**Date:** 8/13/2019  
**To:** North Dakota Public Service Commission  
**Copy to:** Mike Stahly, Cenex Pipeline, LLC  
**From:** Grady Wolf - KLJ  
**RE:** Cenex Pipeline, LLC. Liquid Petroleum Pipeline  
Addendum to Certificate of Corridor Compatibility and Route Permit  
Case No. PU-17-97

**Cenex Pipeline, LLC  
Refined Fuels Pipeline**

**Route Changes  
Within Corridor**

**Re-Route  
FCN ES044**

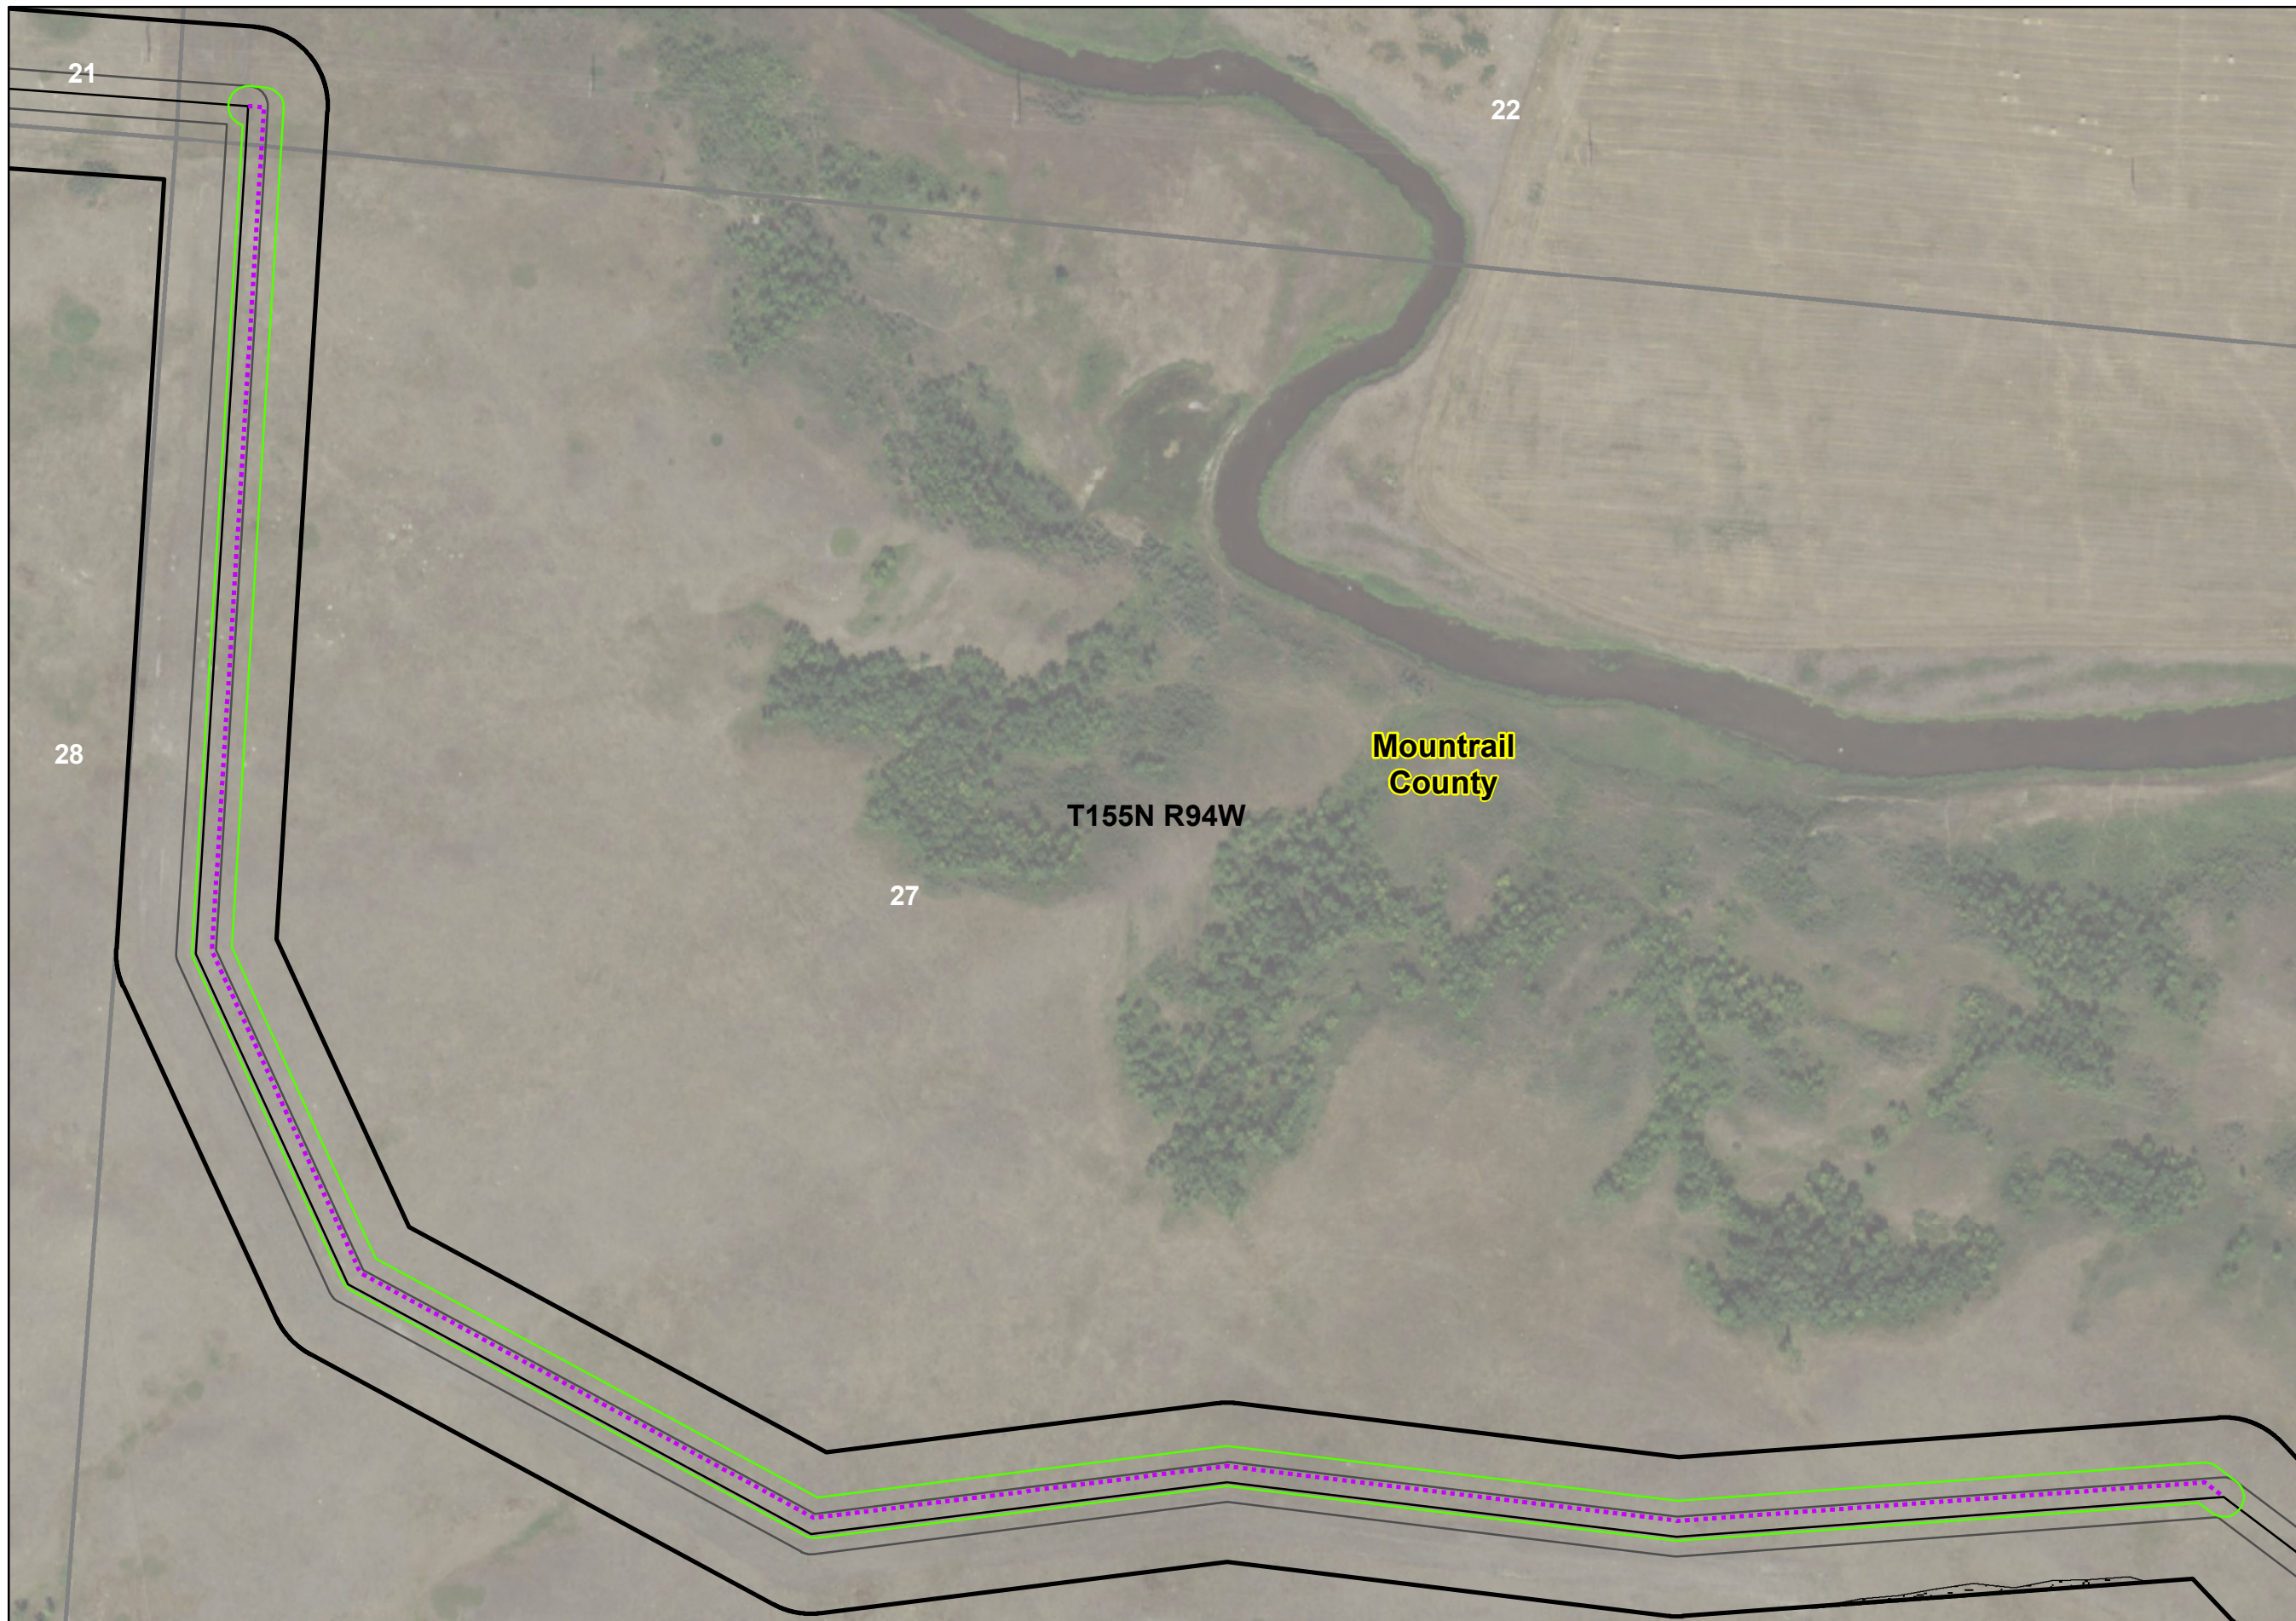
A reroute is being proposed to shift a portion of the route located in Sections 22 and 27, Township 155N, Range 94W, in Mountrail County, North Dakota, to the east and north, moving the pipeline further away from an existing oil and gas pipeline in the vicinity.

Re-Route Length: 3970 FT

**Re-Route  
FCN ES072**

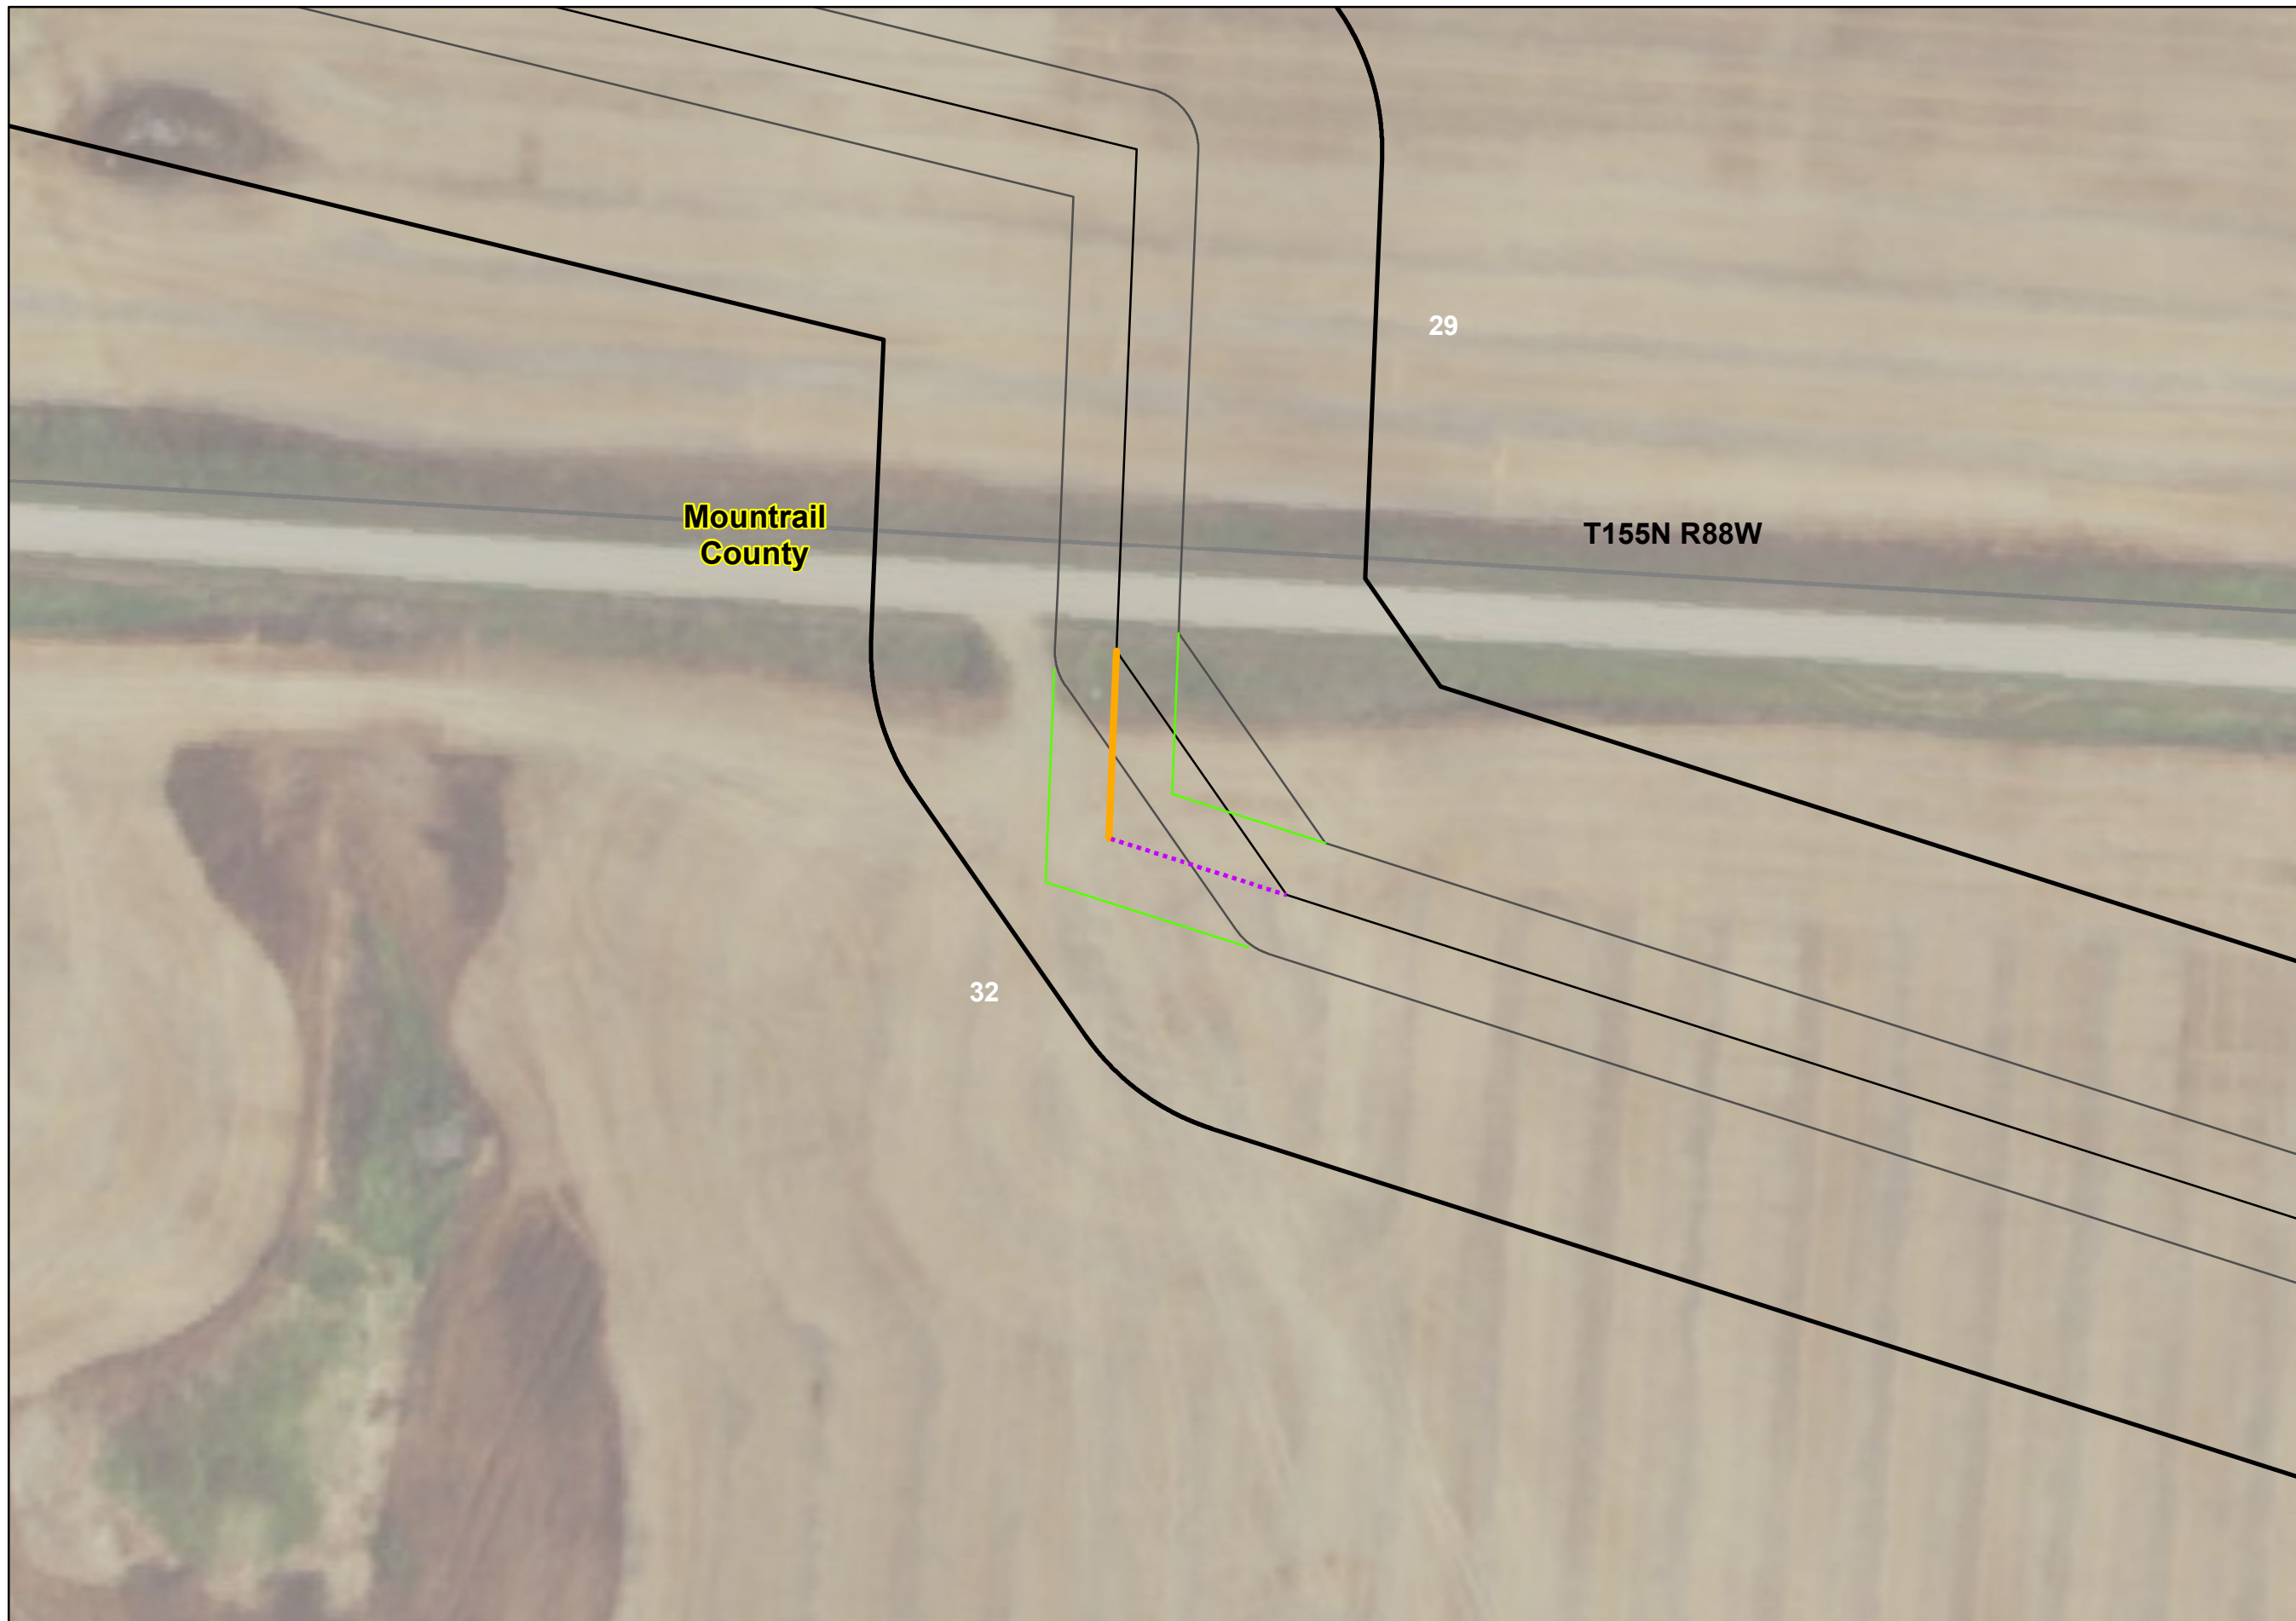
To avoid impacts to a physical encumbrance (county road) in Section 32, Township 155N, Range 88W, in Mountrail County, North Dakota, a reroute is being proposed to extend the pipeline routing to the south to a Point of Intersection (PI) that would return to the existing alignment. The reroute would avoid the encumbrance and remain within the study corridor. This reroute will incorporate a previously identified HDD under a section line road moving the bore location and PI further south.

Re-Route Length: 152 FT
